**FOUNDATION INVESTIGATION REPORT  
FOR  
HEALEY LAKE ROAD UNDERPASS  
W.P. 400-97-01  
G.W.P. 290-97-00, SITE 44-377  
HIGHWAY 69, DISTRICT 52  
HUNTSVILLE, ONTARIO**

**FOUNDATION DESIGN REPORT  
FOR  
HEALEY LAKE ROAD UNDERPASS  
W.P. 400-97-01  
G.W.P. 290-97-00, SITE 44-377  
HIGHWAY 69, DISTRICT 52  
HUNTSVILLE, ONTARIO**

Re: Final Foundation Investigation Reports  
Hwy 69 - Four Laning From Tower Rd. Northerly 26.5 km to North of Hwy 141  
Blackstone/Crane Lake Underpass, W.P. 408-97-01, Site 44-383  
CNR Overhead, W.P. 405/406-97-01, Site 44-381 N&S  
Healey Lake Road Underpass, W.P. 400-97-01, Site 44-377  
Tower Road Underpass, W.P. 399-97-00, Site 44-321  
Airport Road Underpass, W.P. 407-97-01, Site 44-382  
G.W.P. 290-97-00, Hwy 69, District 52, Huntsville

**BOREHOLE LOCATION PLAN AND SOIL PROFILES**

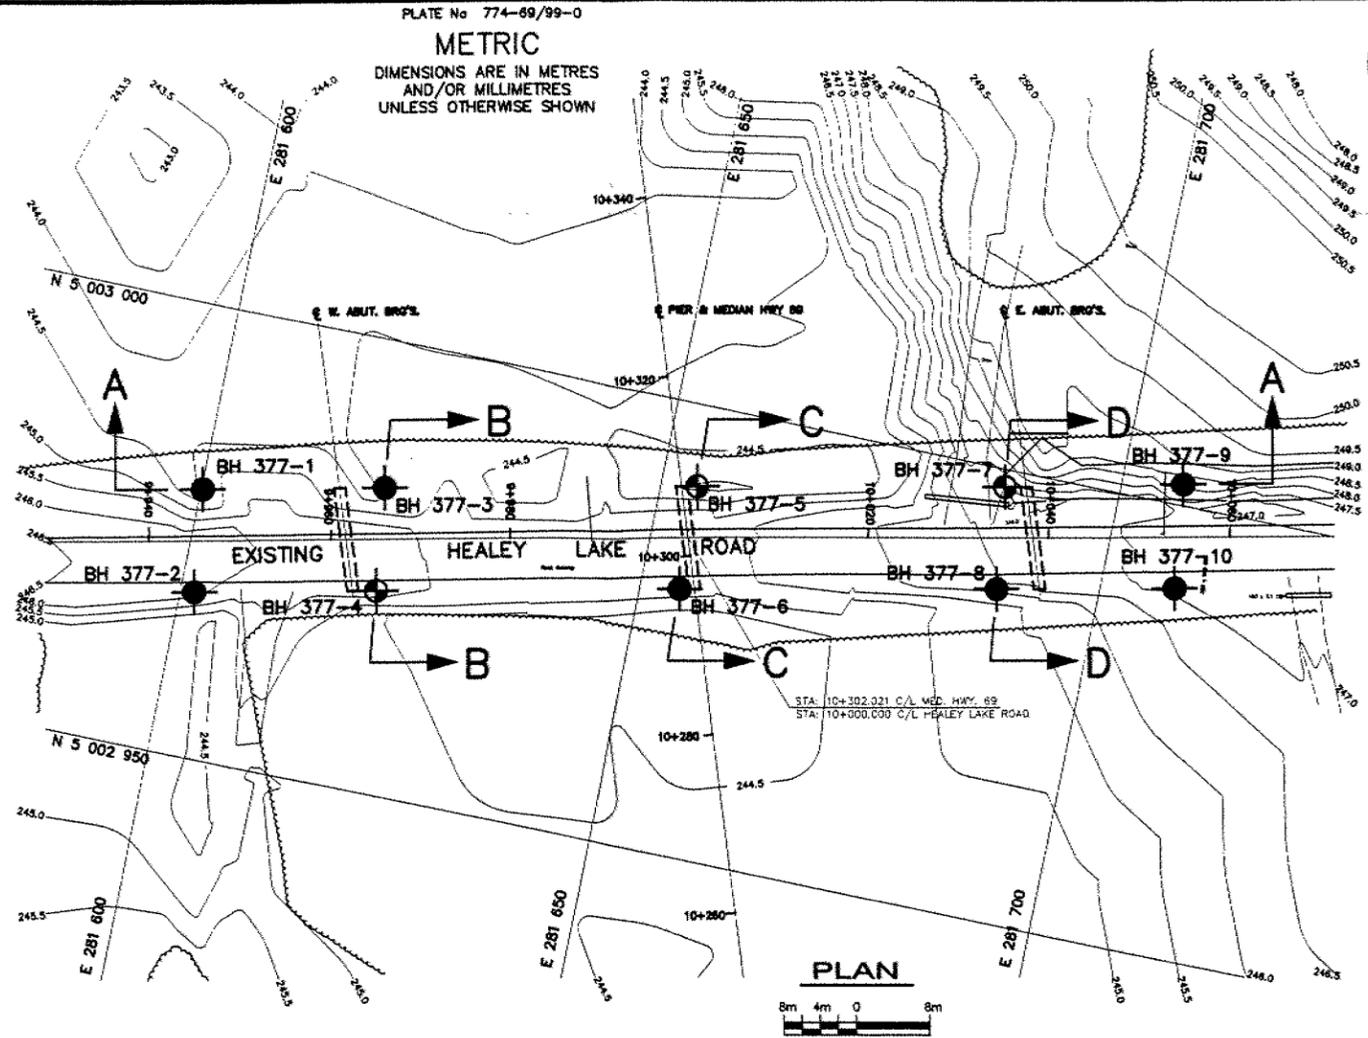
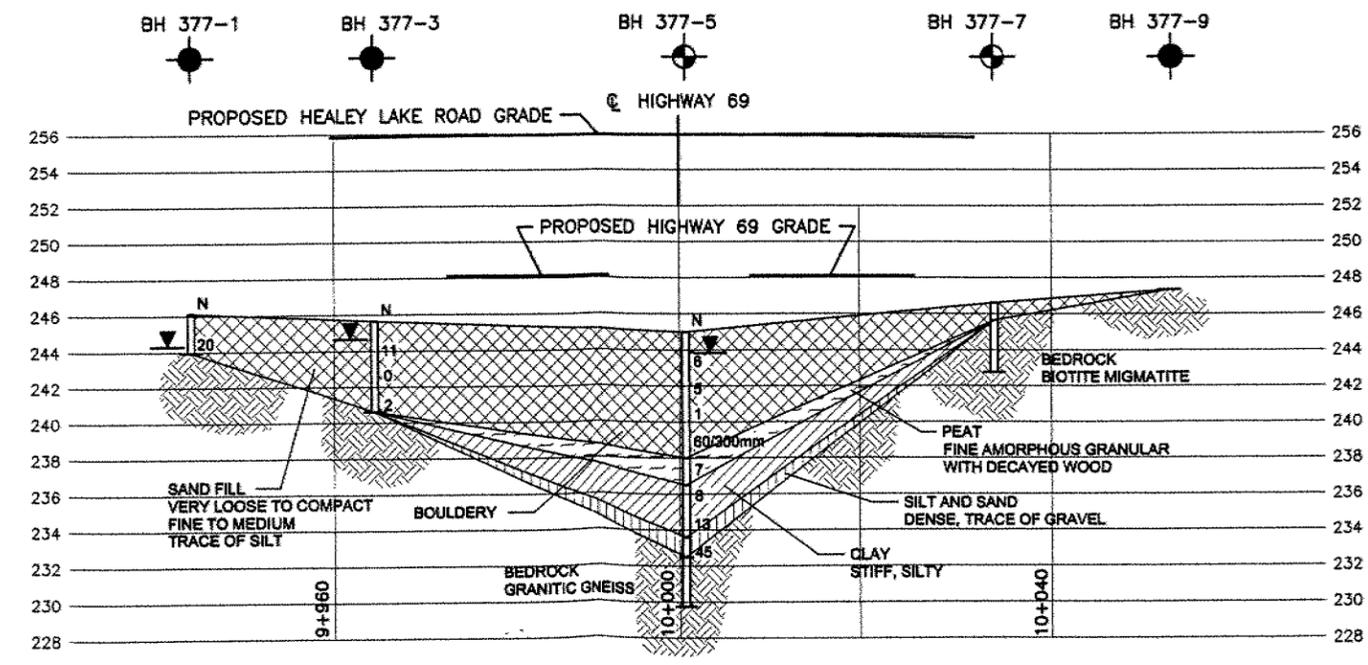
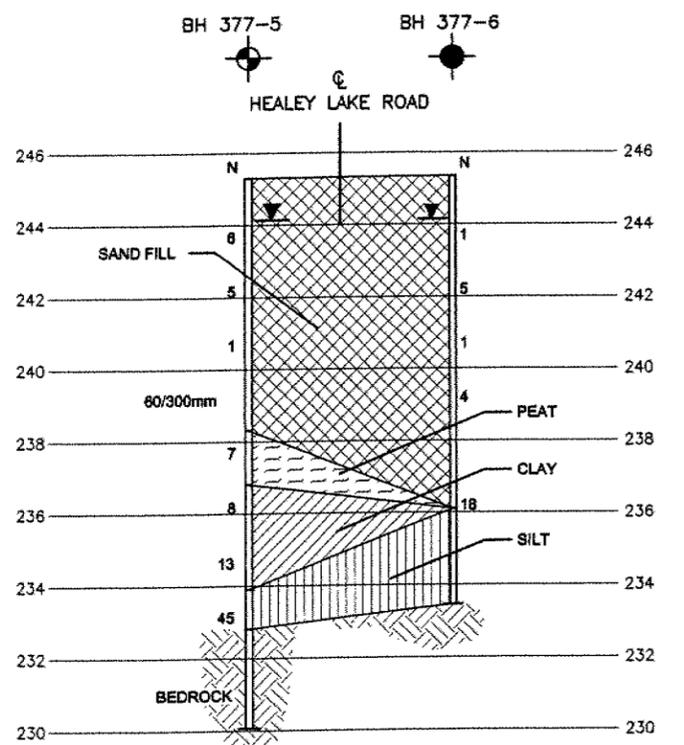
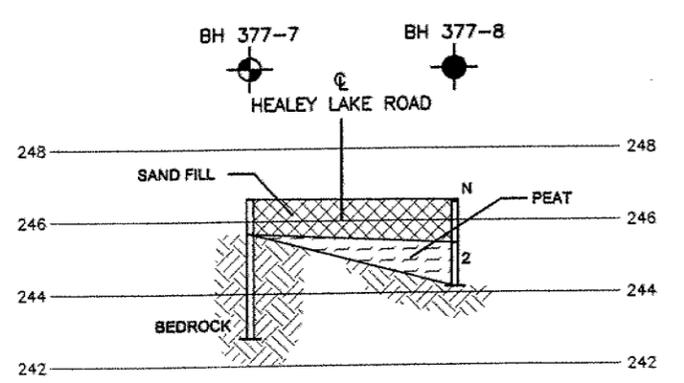
2. Recommendation should be given for the side slopes of the approach fills. ✓
3. The Key Plan, northing and easting and the stations shown on the plan are very small. After the drawings are reproduced to include in the contract package, they would not be legible. ✓

4. The cross sections are very small (some of them are thumb size) and should be enlarged. These cross sections will be included in the contract package. When they are reproduced for the contract package, they would not be legible. The plan is produced in 1:500 scale. The cross sections are normally 100 percent larger than the plans to show the details. But in the report the cross sections are 50 percent reduced. Ideally the cross sections should be in true scale, i.e. same horizontal and vertical scales. If the true scale is not feasible, then the ratio of horizontal and vertical scales should be 2. The ratio of the horizontal and vertical scale in the foundation reports are 5. The cross sections, therefore, are very distorted. All the cross sections do not have to fit on one drawing. Cross sections can be produced on more than one drawings. A sample copy of the standard drawing can be obtained from the Pavements and Foundations office. ✓

5. A bar scale, similar to the one provided on the plan should also be provided on the cross sections. ✓
6. The Pavements and Foundations Section has assigned Geocres Numbers for these projects. The Consultant should provide the Geocres numbers on the Final Reports. The Geocres number shall be shown on the lower left corner of the Title Page of the Foundation reports. ✓
